ADDENDUM NO. 1

Job No. F70C616E
SAND ISLAND STATE RECREATION AREA
SEWER SYSTEM IMPROVEMENTS
PHASE 2: PUMP STATION 3 RELOCATION & FM 3 REPLACEMENT
Honolulu, Oahu, Hawaii

02/22/21

| APPROVED: | DRAWING NO. E-6 | |

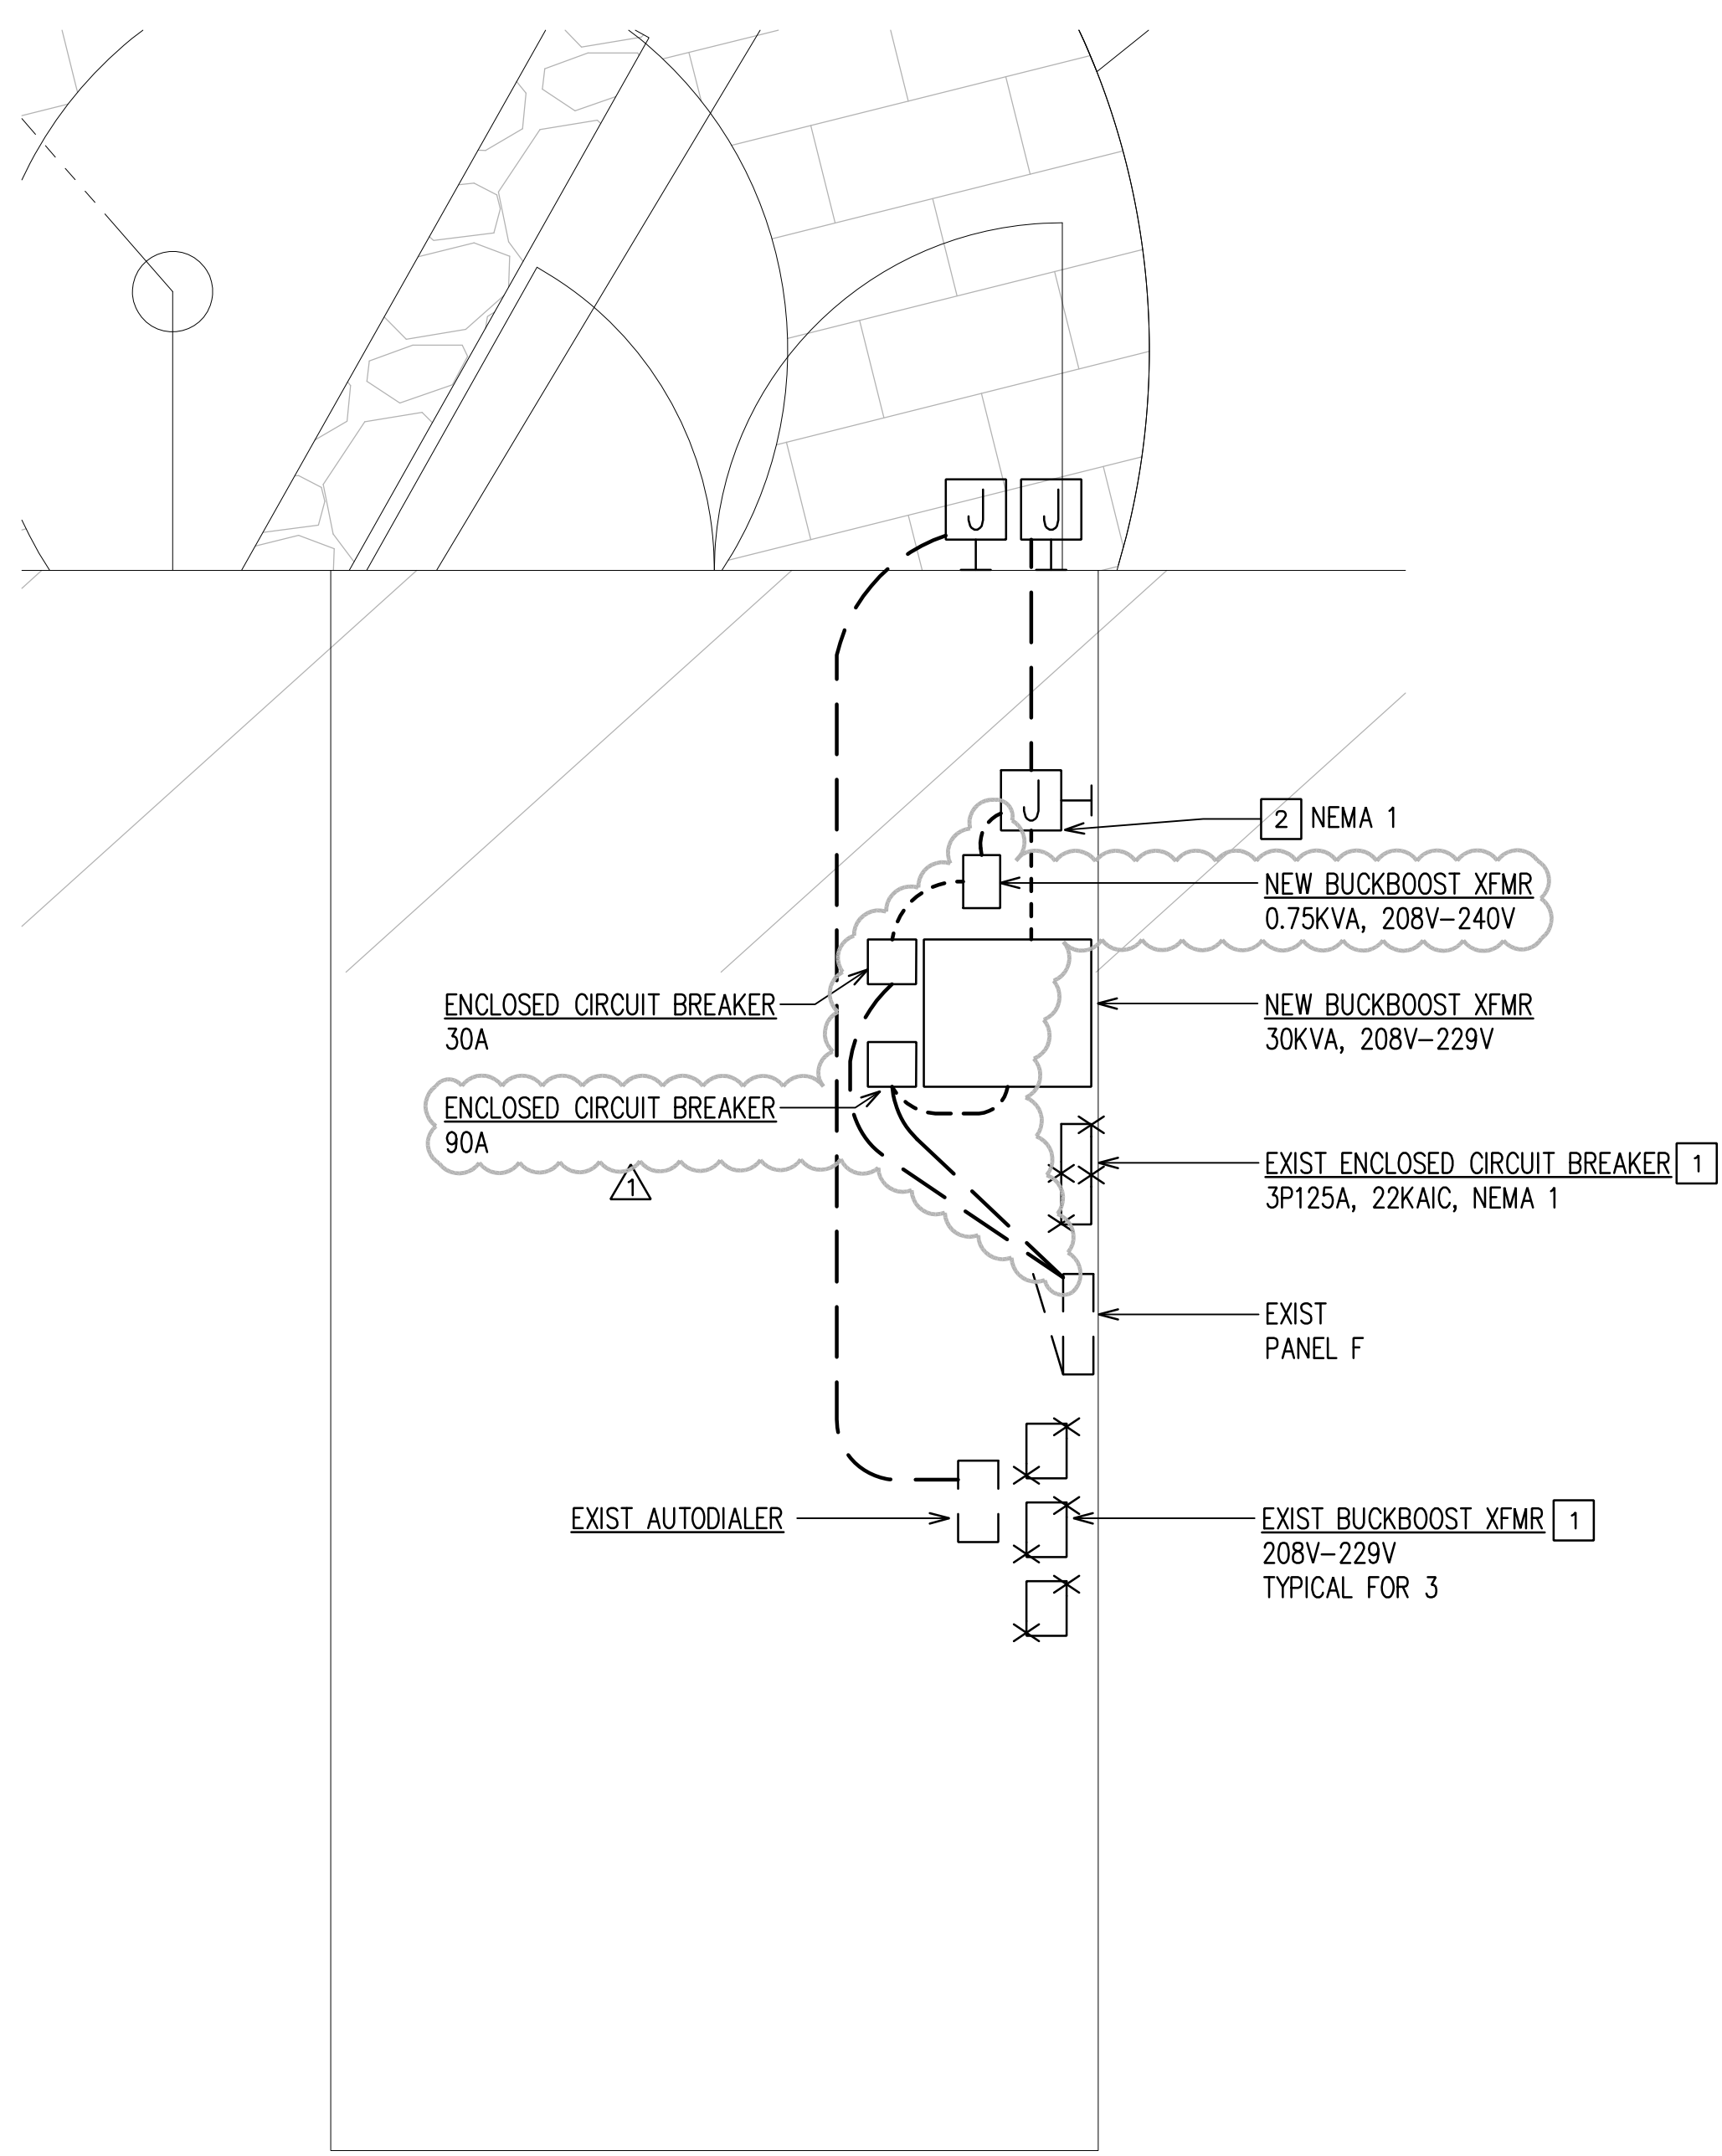
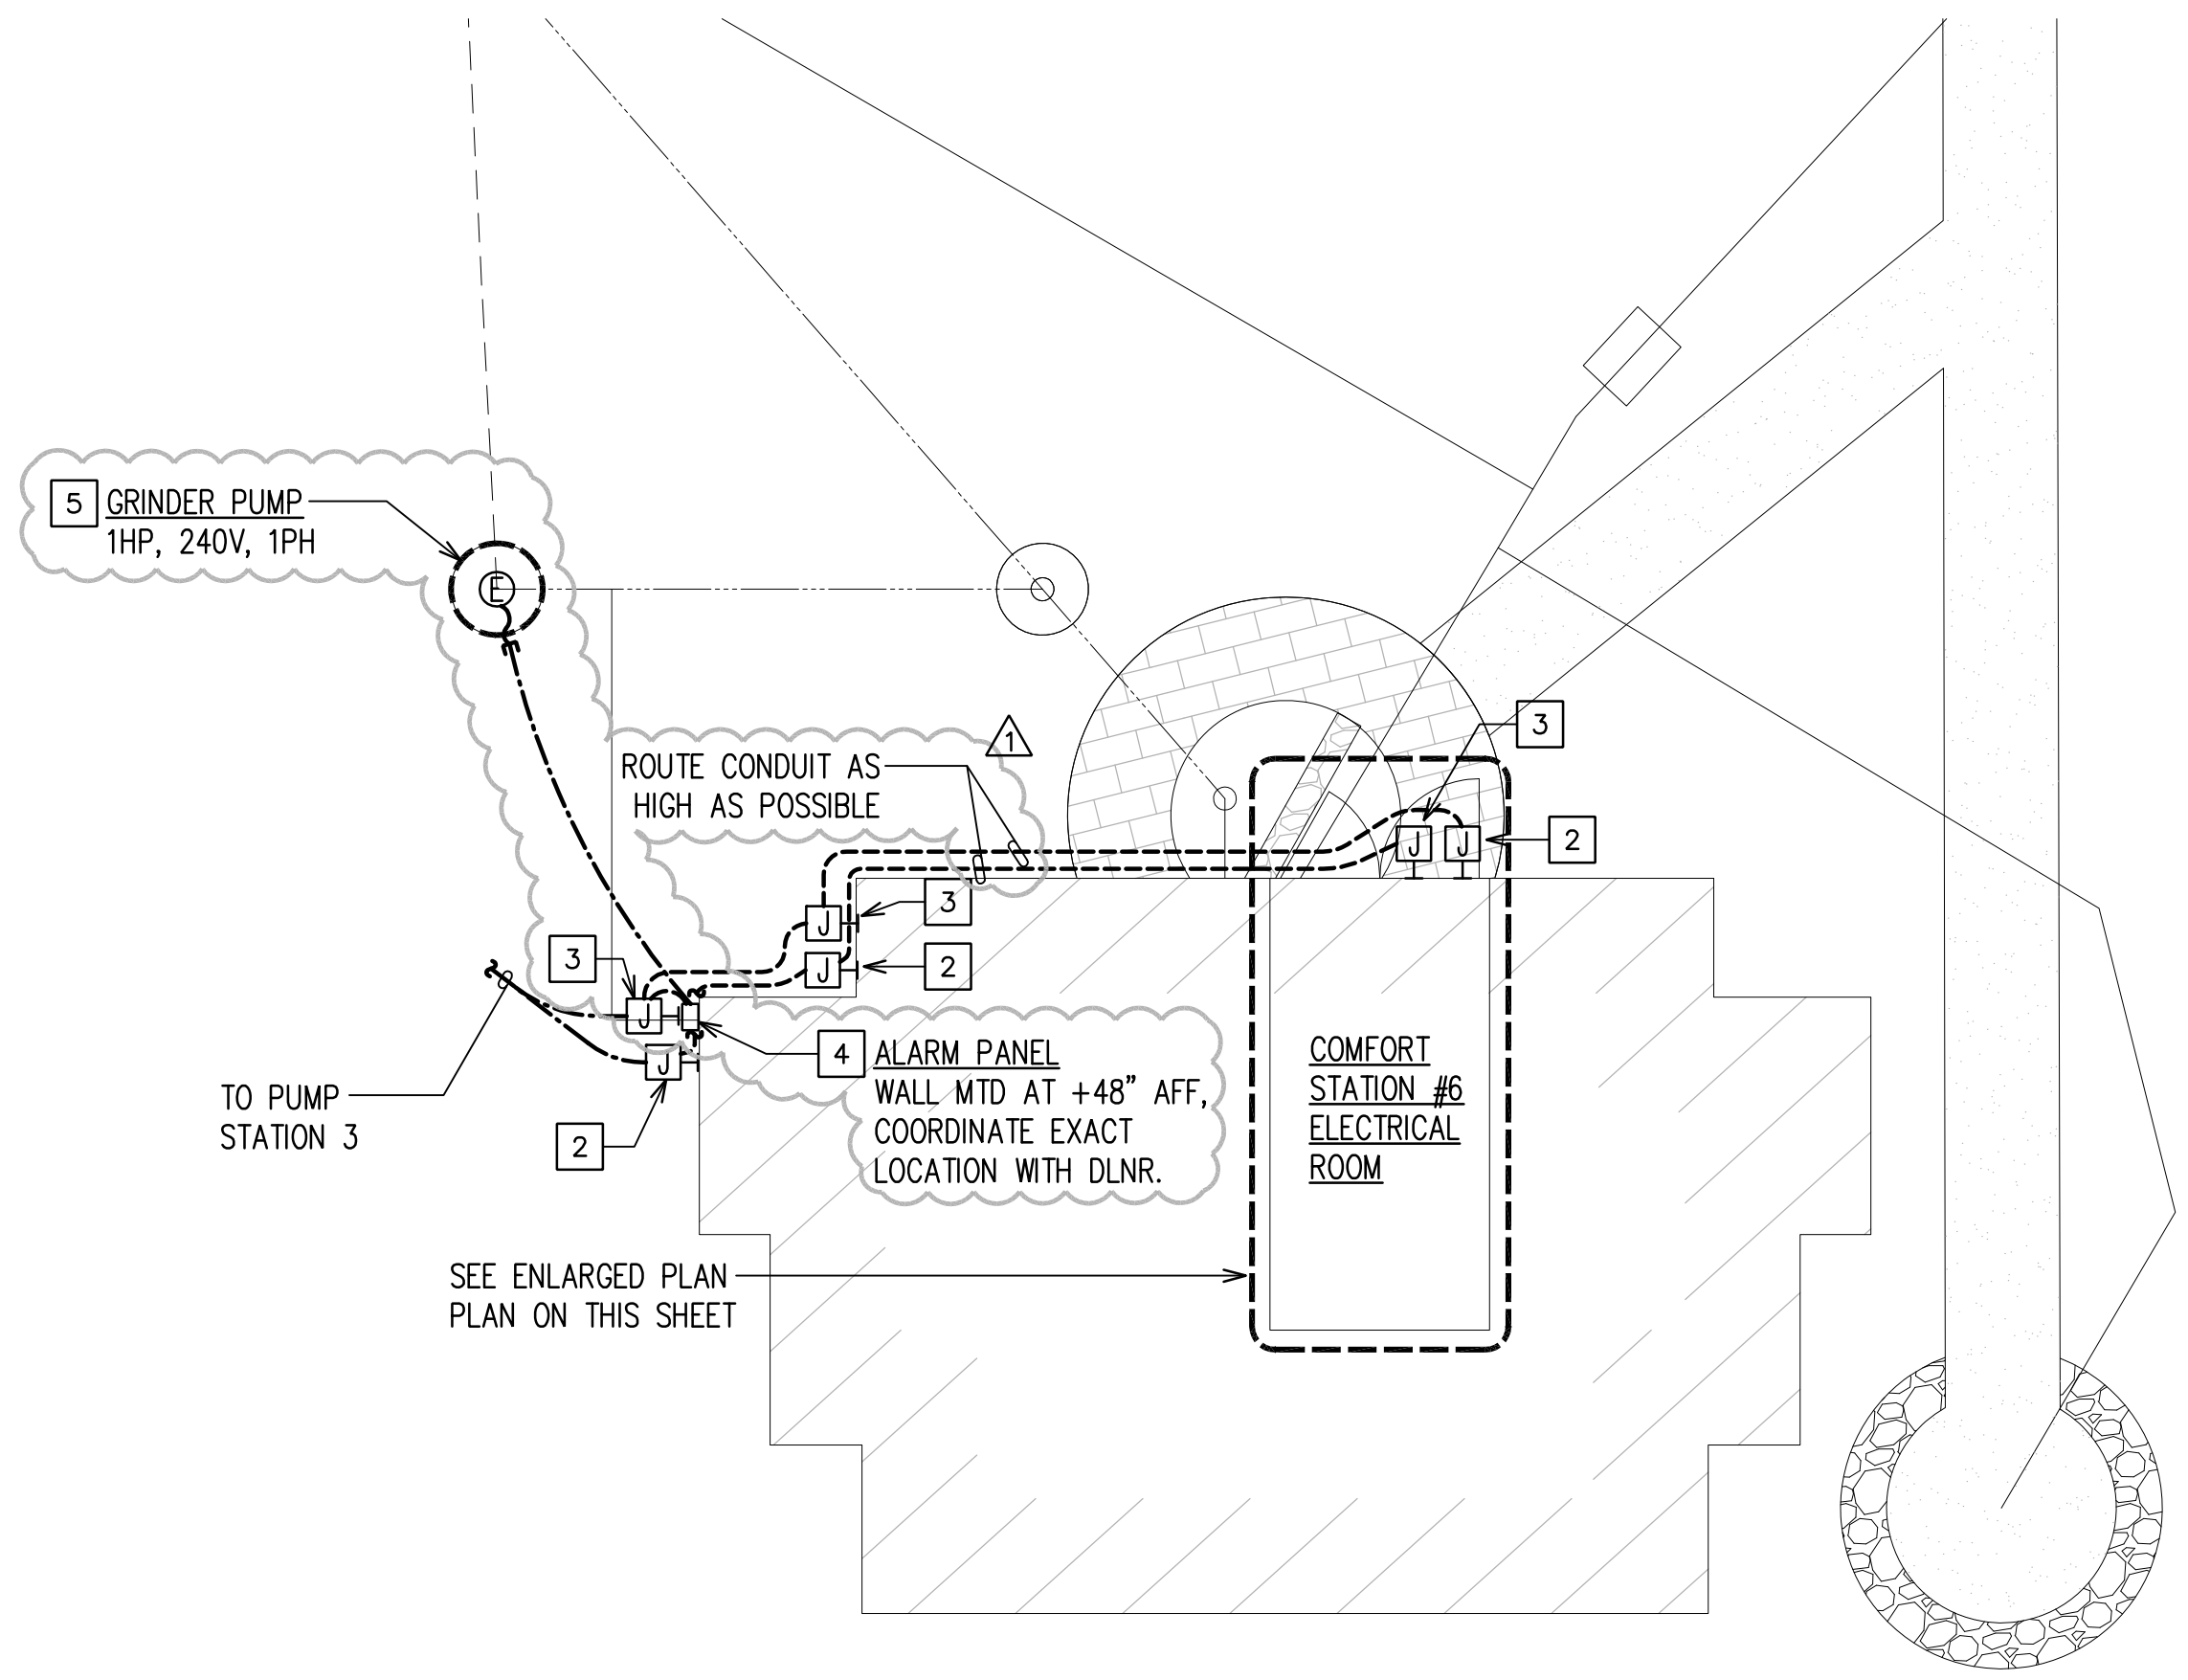
- a. Added electrical connection and alarm panel for grinder pump.
 - b. Added new enclosed breaker for new pump station 3.
 - c. Added new buckboost transformer for new grinder pump.
